## Pennsylvania Department of Environmental Protection

Telecopy Transmittal

Safety Light Response to the  
Work Plan questions.

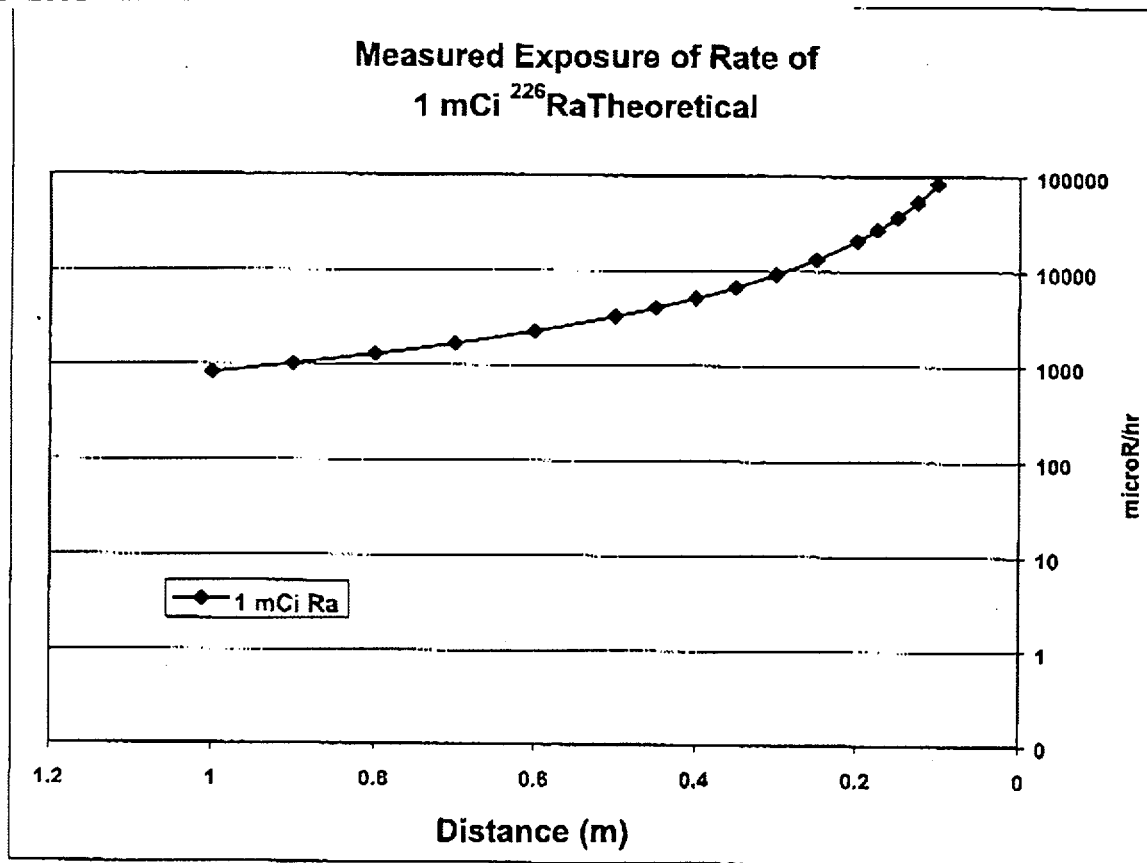
- 13. Section 11.1 refers to a dose vs. distance conversion for Ra-226, which follows. However, the information is missing from this section.**

To quantify the activity, the exposure rate of an item with a near point geometry will be measured at several distances and compared to the theoretical exposure rates from a one (1) milliCurie point source of radium, as shown on the following graph. Items with a very low activity may be grouped to reduce measurement error. Data obtained during the project will be plotted and the resulting lines compared to determine the shape of the measured data.
